UNITED STATES PATENT AND TRADEMARK OFFICE

APPLICATION NO.	FILING DATE	FIRST NAMED INVENTOR	ATTORNEY DOCKET NO.	CONFIRMATION NO.
10/730,834	12/08/2003	Nick Kuo	JCLA11759	5204
27765	7590	07/05/2006	EXAMINER	
NORTH AMERICA INTELLECTUAL PROPERTY CORPORATION P.O. BOX 506 MERRIFIELD, VA 22116			ANDUJAR, LEONARDO	
			ART UNIT	PAPER NUMBER
			2826

Office Action Summary	Application No.	Applicant(s)	
	10/730,834	KUO ET AL.	
	Examiner	Art Unit	
	Leonardo Andújar	2826

DETAILED ACTION

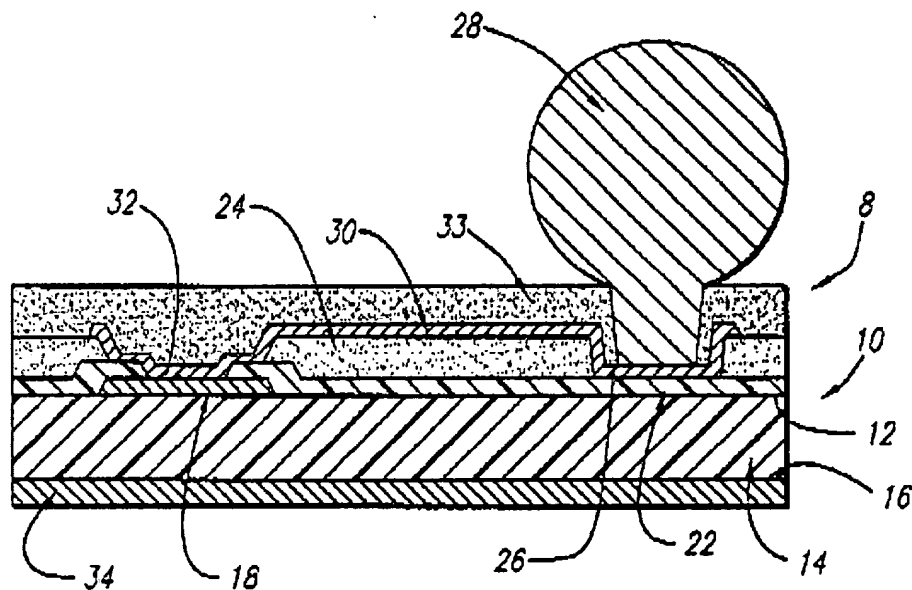
2. Applicant's election without traverse of species 4 (figs. 1d and 2d) in the reply filed on 9/07/2005 is acknowledged. Amended claims 23-24, 35, 37 and 46-50 were withdrawn from consideration because they are not supported by the elected species. Note that in figure 2 does not show "a third portion" (emphasis added). Note that the elected species includes only two portions one for a solder bump connection and a second one for testing or wire bonding.

FIG.3

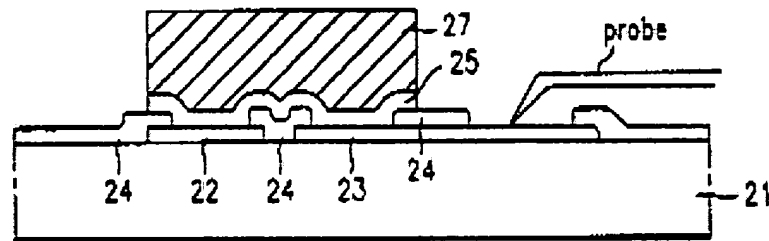
Elenius does not teach a testing pad or second portion used to be tested thereto. Nevertheless, Kim (e.g. fig. 3) shows a testing pad 23 electrically connected to a bump pad 22. This type of embodiment prevent decreases in testing reliability caused by damages on the surface of the bump and polluting material thereby enhancing its yield with respect to bonding (col. 2/ls. 10-30).

It would have been obvious to one of ordinary skill in the art at the time the invention was made to include a second portion used to be tested thereto or include a test pad electrically in order to prevent decreases in testing reliability caused by damages on the surface of the bump and polluting material during the testing process, thereby enhancing its yield with respect to bonding as taught by Kim.

FIG. 2I

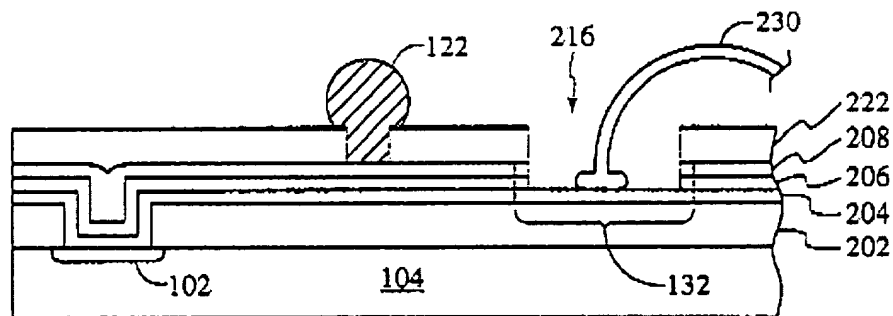
24. Regarding claim 27, Lam (e.g. fig. 2A-2I) shows a semiconductor substrate 104; a bond pad 102 structure over the semiconductor substrate; a passivation layer 202 exposes a top surface of the metallization structure; a patterned circuit layer 204-208 connected to the top surface, wherein the patterned circuit layer comprises a first portion 214 having a bump 122 formed thereover and a second portion 216 used to be wirebonded thereto (col. 1/23-33 & co. 2/lls. 30-51).

Lam does not explicitly disclose that the bond pad structure 102 is a metallization structure. Nevertheless, Liao (e.g. fig. 3) shows an analogous circuitry including a bond pad 14, which is a metallization structure.
